Prepared by Caroline Wenger  
(Co-convenor of Umbagog Landcare Group)  
in consultation with ULG members

Submission to:

A.C.T. Environment, Planning and Sustainable Development Directorate – Planning

**Re: Development Application number: 202240445**

**Photos 11 and 12**– maidenhair fern in a different part of the bridge also located at bridge level. A closeup of fern (top) and a photo of the same (below) showing its proximity to the edge of the bridge.

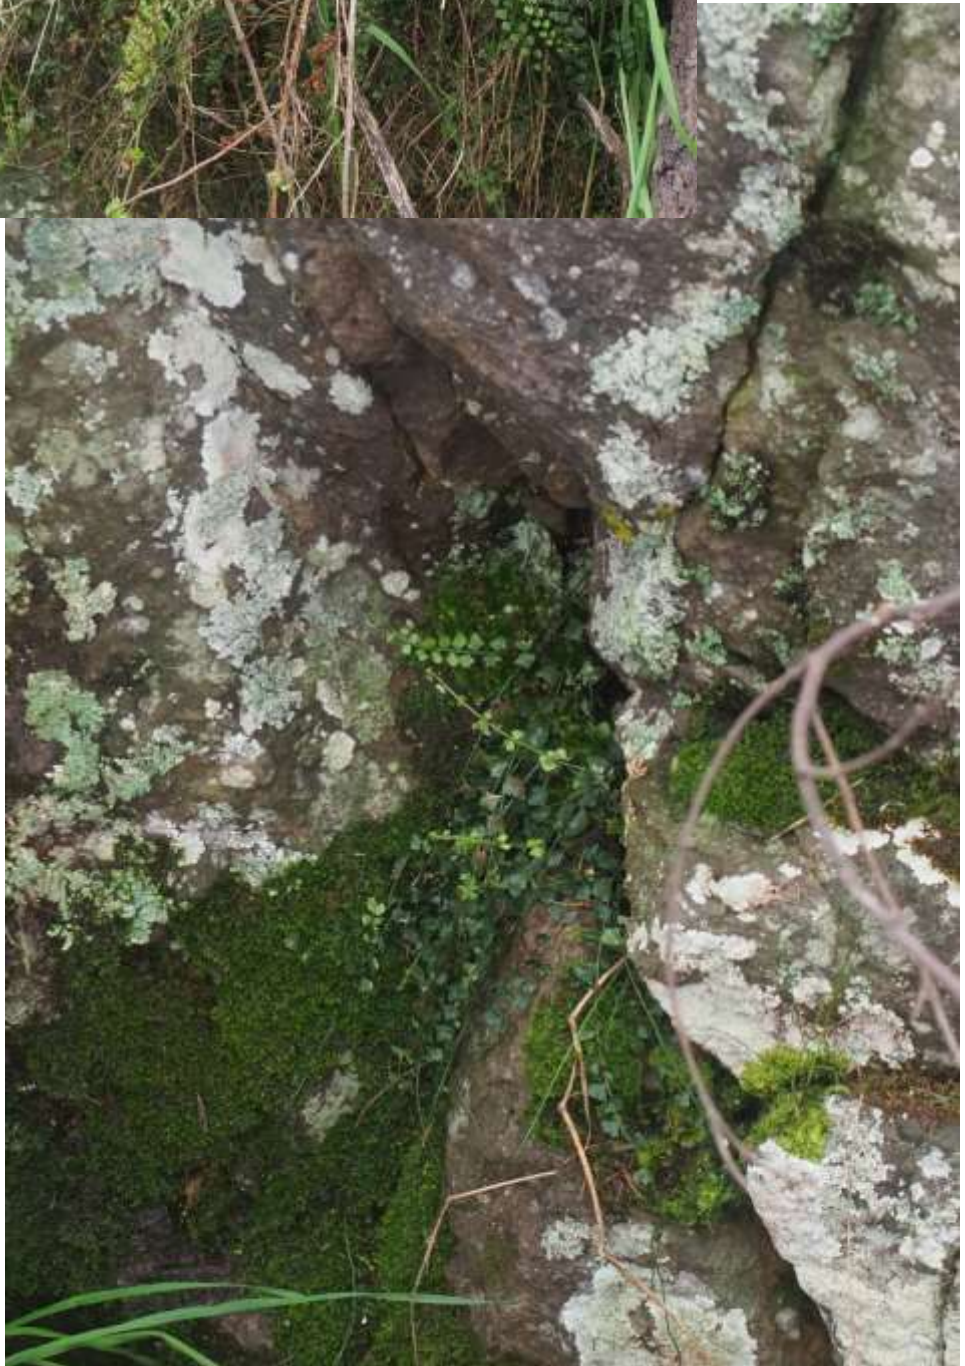
The site of bridge 1193 is the most sensitive and has a number of plants not found anywhere else in the park, including some species of fern, (unfortunately some of them only found at bridge level: see Photos 10-20).

Care must be taken not to disturb these ferns during bridge demolishing / construction as they only seem to occur on this level.

**RECOMMENDATION 2.3: That TCCS and contractors work with ULG to minimise damage to sensitive vegetation at each site.**
